Enclosure 1

NRC RAIs on WCAP-16308-NP, "Pressurized Water Reactor Owners Group 10 CFR 50.69 Pilot Program – Categorization Process – Wolf Creek Generating Station", Letter from Tanya Mensah (NRC) to Biff Bradley (NEI) dated August 28, 2007 (ML072220129)

Figure I-1
Risk-Informed Safety Classification Process

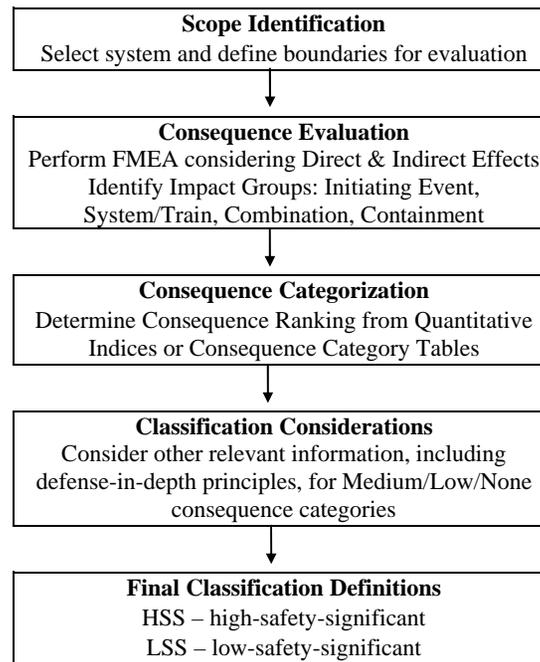
I-1.0	N/A	Added figure ¹ illustrating the modified RISC methodology process, including scope identification, consequence evaluation, consequence categorization, classification considerations, and final classification definitions.	Figure added to provide high level overview of RISC methodology process. New process calls for all segments to be included in the consequence evaluation to determine high, medium, low or none consequence category. Then only the non-high category segments would be considered in the classification considerations of I-3.2.2(b) – previously I-3.1.3.
